NOTES: (UNLESS OTHERWISE SPECIFIED)		DIMENSIONS ARE IN mm [INCHES]		CALIFORNIA INSTITUTE OF TECHNOLOGY MASSACHUSETTS INSTITUTE OF TECHNOLOGY IGR, GLASGOW UNIVERSITY GEO 600 GROUP RUTHERFORD APPLETON LABORATORIES

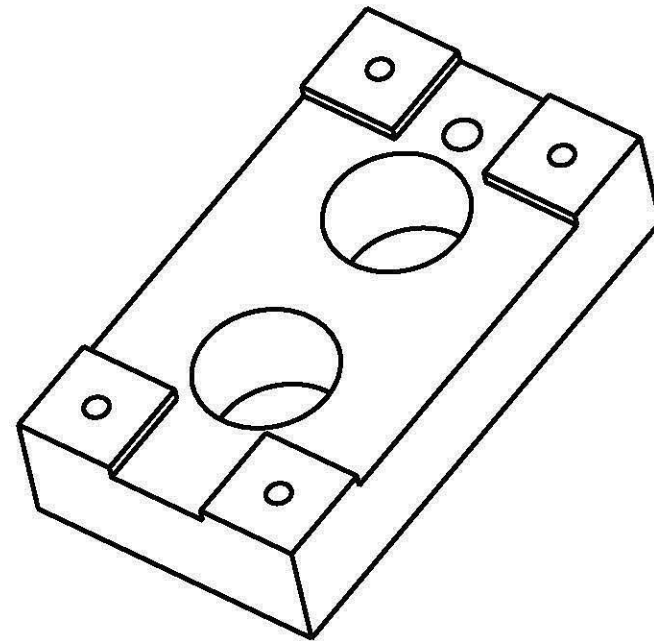
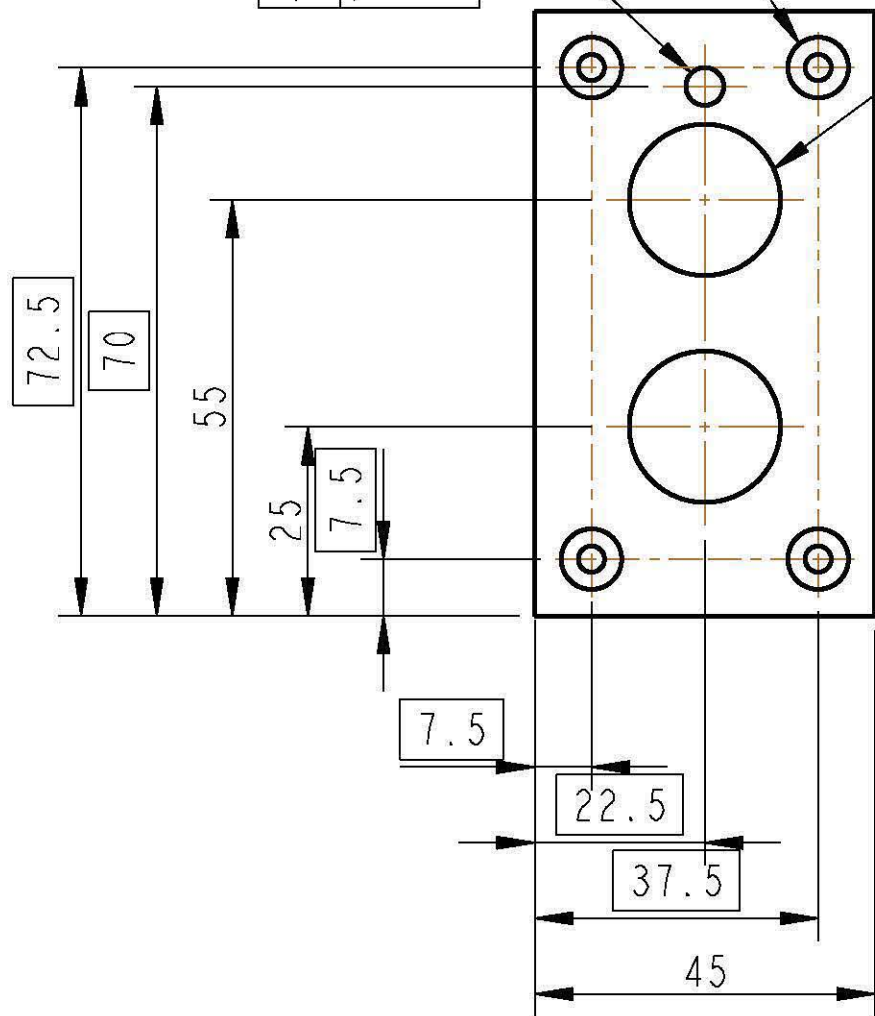
SEE NOTE 5:
 MODIFY THIS PART, CROSS OUT EXISTING PART NUMBER AND ADD D070247-V3 - REV C S/N 001
 OPP, SIDE OK
REFERENCE:
 S/N NUMBER 001, 002, 003, AND SO ON

MODIFY THIS HOLE: IS 10mm MAKE 20mm DIA. 2PL THRU
